Town of Franklin

Planning Board

September 28, 2020

DATE: September 23, 2020
TO: Franklin Planning Board
FROM: Department of Planning and Community Development
RE: Lakeview Terrace – Private Subdivision
Partial Form H

DES BY: JJS DATE: 09/09/20
CHK BY: BJA PROJECT NO. 2018-259 **AB-1**

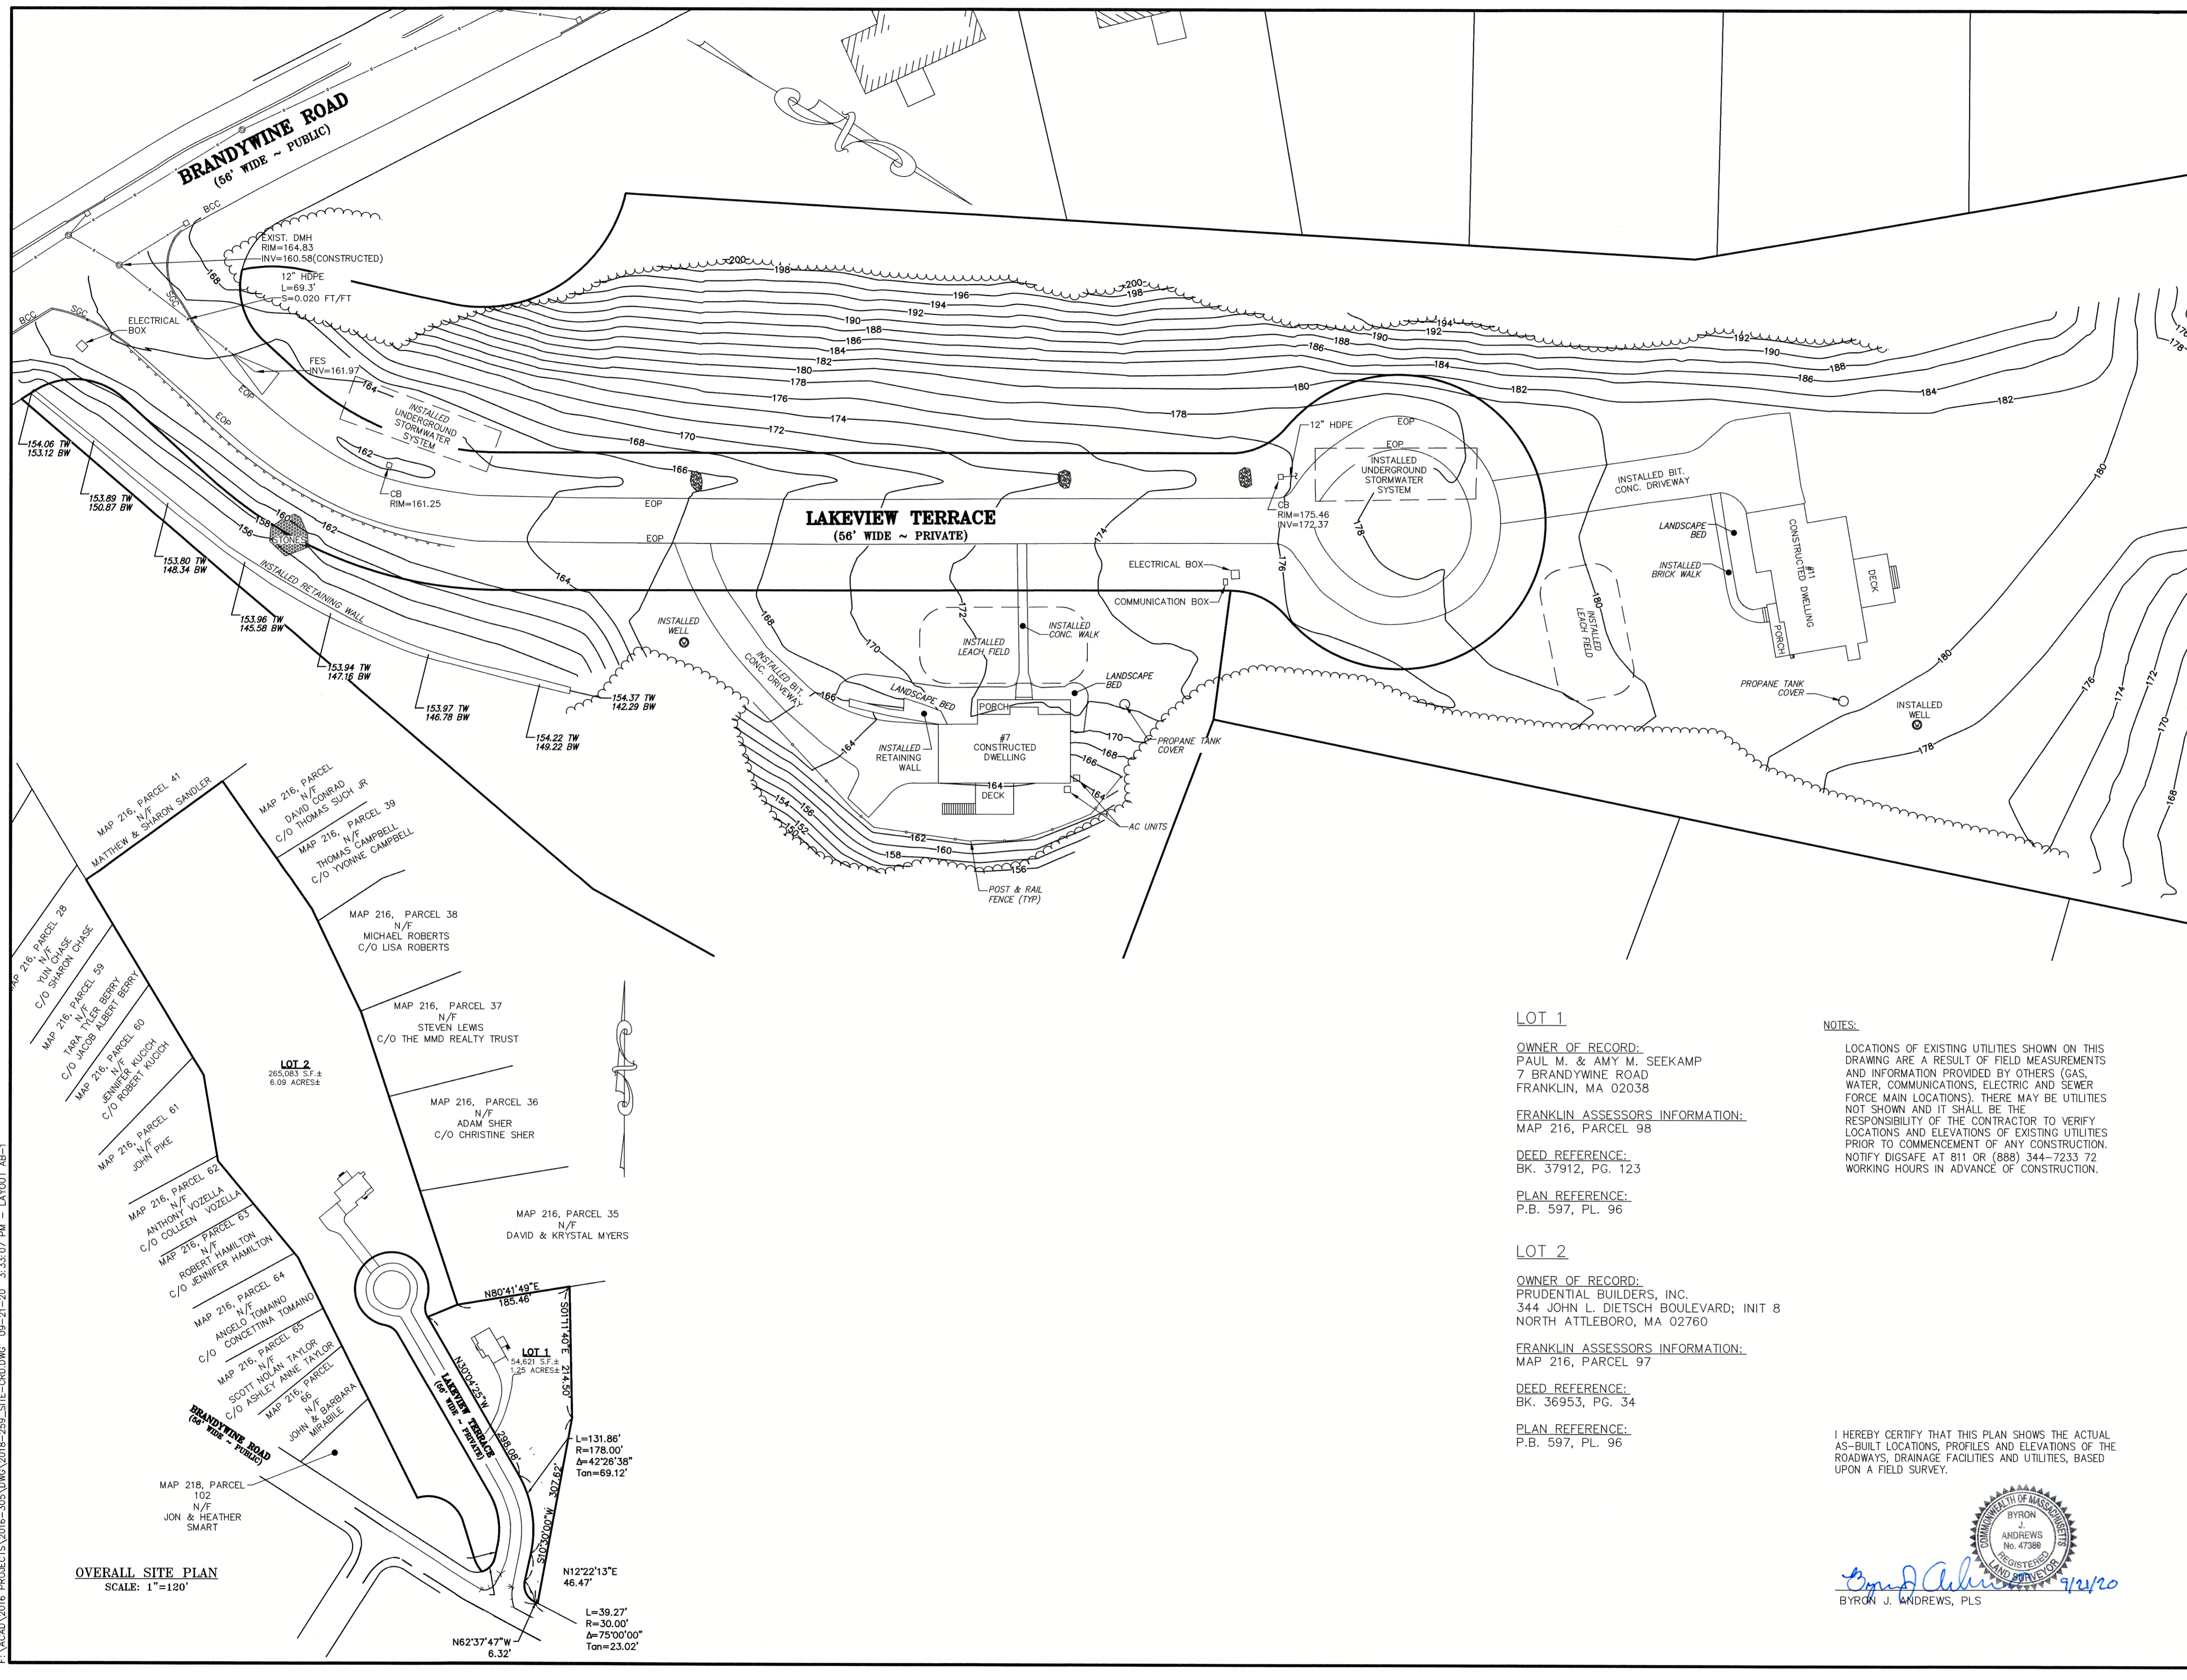
The following work needs to be completed or revised at the referenced site.

2. The swale along the left side of the roadway from the beginning of the street to the new swale at station 2+50 needs to be regraded, loamed and seeded. A great deal of soil material has filled in the swale near the catch basin at station 1+20 +/-.
3. The swale around the left side of the cul de sac is filled with sediment and needs to be regraded, loamed and seeded.
4. The roadway bounds have not been installed as shown on the approved plans.

- Items included on the Subdivision Work Completion List and as described in the letter from Andrews Survey and Engineering, dated September 21, 2020.
- The Engineer of Record has indicated that the erosion problem along the slope above the retaining wall is a result of the catch basin in the swale being covered and flow overtopping the roadway; however, the as-built plan also indicates that the cross-slope of the roadway near the intersection of Brandywine Road is pitched toward the slope above the retaining wall. It is anticipated that stormwater will continue to flow toward the eroded slope unless measures are implemented to direct roadway flow to the swale as depicted on the Approved Plans.

SINGLE FACE GUARD RAIL WITH WOOD POST
N.T.S.

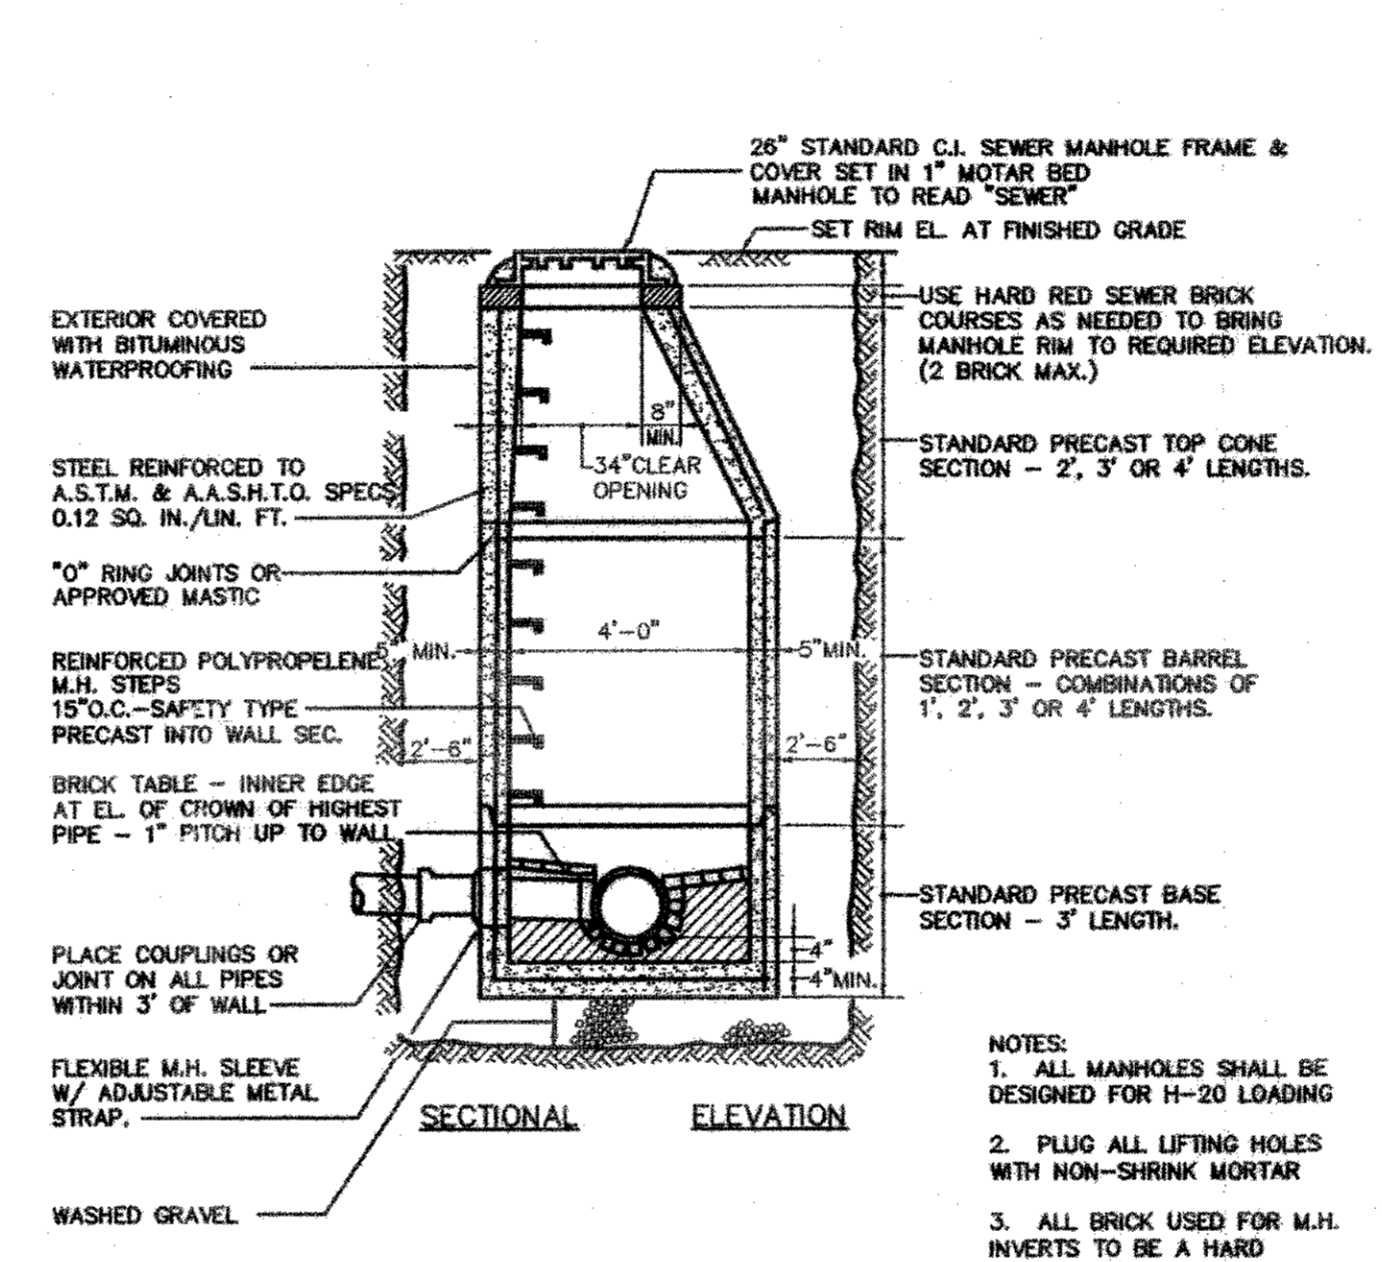
- The installed wooden guardrail does not appear to conform to the detail/notes on the Approved Plans. BETA has requested that the design engineer confirm the installed guardrail meets the intent of the approved design.

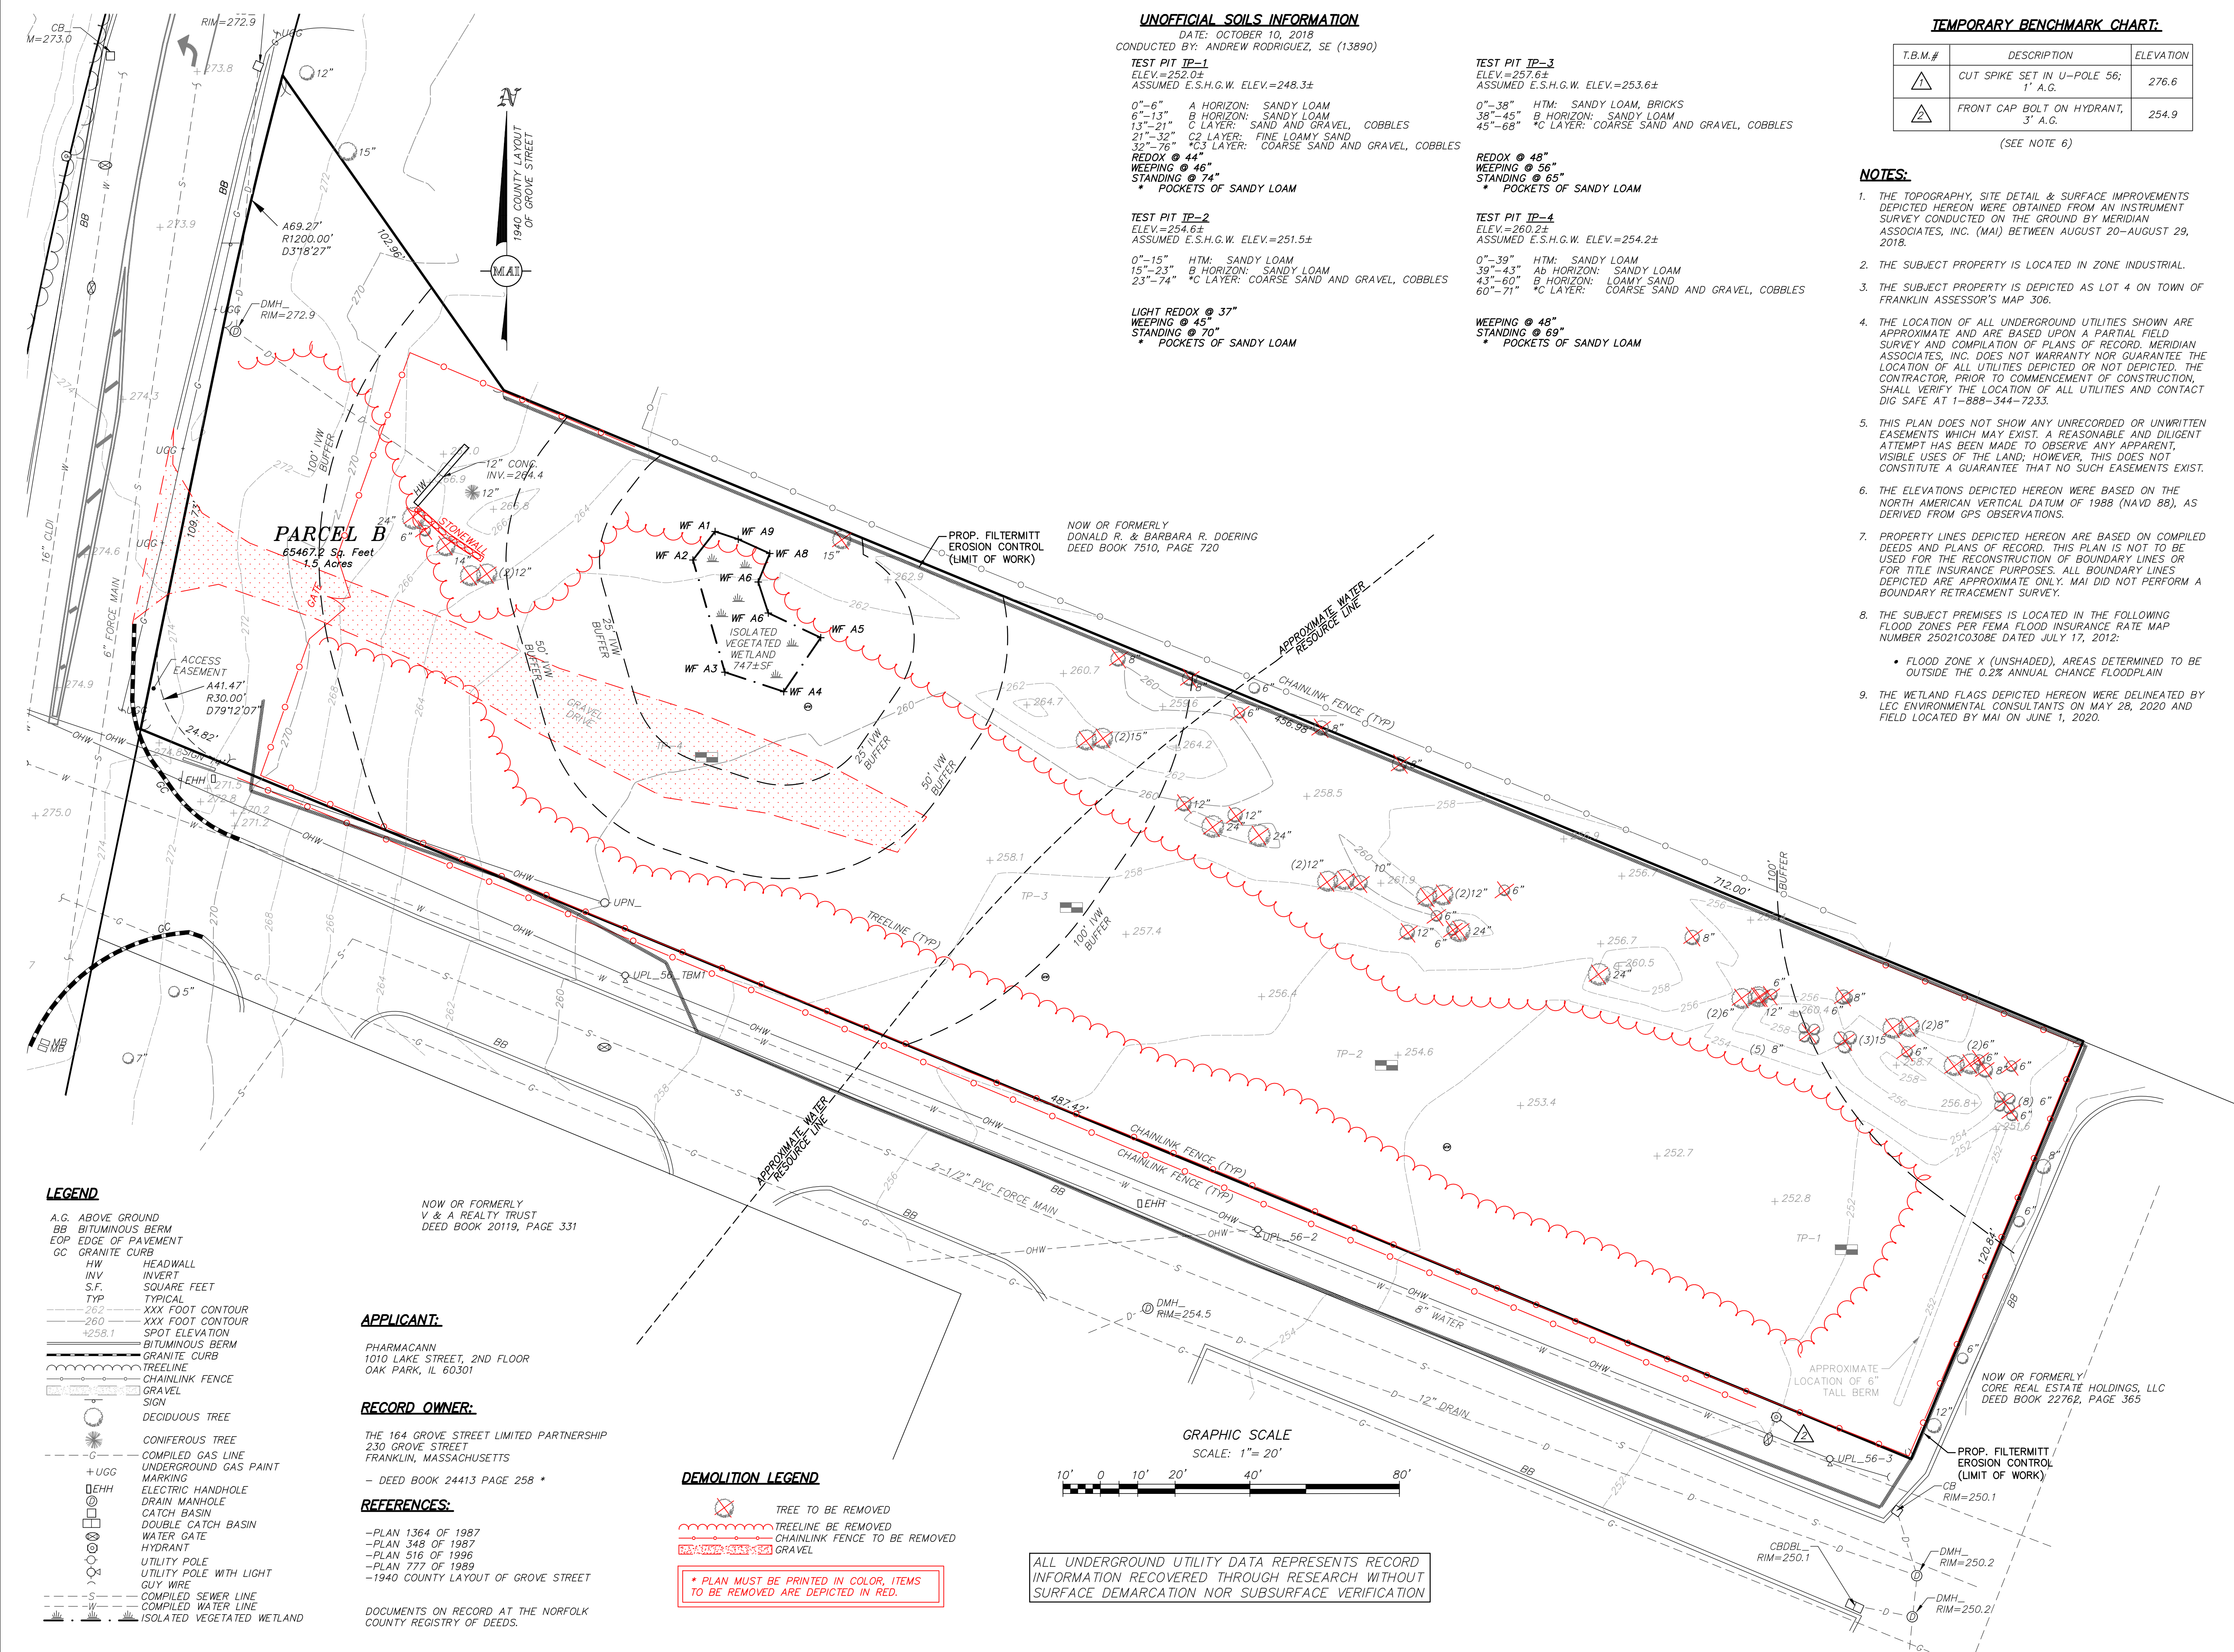
G3. Clarify the disposition of the existing fences and gate surrounding the property. *MAI: The existing fence around the perimeter of the site, that is located within the property lines, is to be removed. Refer to Sheet C 1.0.* BETA2: Clarification provided. It is anticipated that any fence removal outside of the property line will be coordinate with the ongoing access and easement negotiations – issue resolved.

- G3. Clarify the disposition of the existing fences and gate surrounding the property. *MAI: The existing fence around the perimeter of the site, that is located within the property lines, is to be removed. Refer to Sheet C 1.0. BETA2: Clarification provided. It is anticipated that any fence removal outside of the property line will be coordinate with the ongoing access and easement negotiations – issue resolved.*
